Access Compliance Report

Public Rights-of-Way

(Pedestrian Signals)

Intersection ID: N/A	Main Street:	Cross Street: N/A	Location: N/A
ADA ID: 3D7A8B9E2350	Signal Type: One Push Button-Non APS	Overall Compliance: No	Severity Score: BTN 1: N/A BTN 2: N/A No BTN: N/A
Codes/Mitigation Info/Possible Solution		Field Measurements/Component Compliance

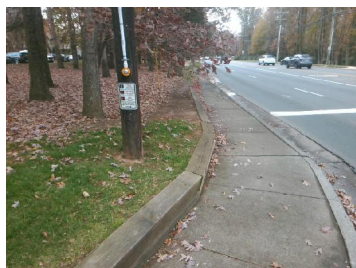
PROW/ADA: TMUTCD 4e.08, R404.1, R404.7.1, R404.7.2, R406

N/A	B 1 FWD Approach Width (in)	N/A	N/A	B 2 FWD Approach Width (in)	N/A
N/A	B 1 FWD Approach Obstruction?	N/A	N/A	B 2 FWD Approach Obstruction?	N/A
N/A	B 1 FWD Approach Obstruction Dist (in)	N/A	N/A	B 2 FWD Approach ObstructionDist (in)	N/A
No	B 1 PARA Approach?	No	N/A	B 2 PARA Approach?	N/A
N/A	B 1 PARA Approach Constrained?	N/A	N/A	B 2 PARA Approach Constrained?	N/A
N/A	B 1 PARA Approach Reach (in)	N/A	N/A	B 2 PARA Approach Reach (in)	N/A
N/A	B 1 PARA Approach Width (in)	N/A	N/A	B 2 PARA Approach Width (in)	N/A
N/A	B 1 PARA Approach Obstruction?	N/A	N/A	B 2 PARA Approach Obstruction?	N/A
N/A	B 1 PARA Approach Obstruction Dist (in)	N/A	N/A	B 2 PARA Approach ObstructionDist (in)	N/A
N/A	B 1 Clear Floor Space Slope (%)	N/A	N/A	B 2 Clear Floor Space Slope (%)	N/A
N/A	B 1 Clear Floor Space XSlope (%)	N/A	N/A	B 2 Clear Floor Space XSlope (%)	N/A
N/A	B 1 PAR Slope (%)	1.3	N/A	B 2 PAR Slope (%)	N/A
No	B 1 Height (in)	54.0	N/A	B 2 Height (in)	N/A

Yes	B 1 Clear Xing Direction?	ClearlyMarked	N/A	B 2 Clear Xing Direction?	N/A
	B 1 Crossing Direction	To SW		B 2 Crossing Direction	N/A
Yes	B 1 DistanceTo XWalk (in)	60.0	N/A	B 2 DistanceTo XWalk (in)	N/A
No	B 1 DistanceTo Curb (in)	91.0	N/A	B 2 DistanceTo Curb (in)	N/A
Yes	B 1 Diameter (in)	2.0	N/A	B 2 Diameter (in)	N/A

Possible Solutions: Replace Signal Push Button With APS Button on New Post. Remove & Relocate Sign.
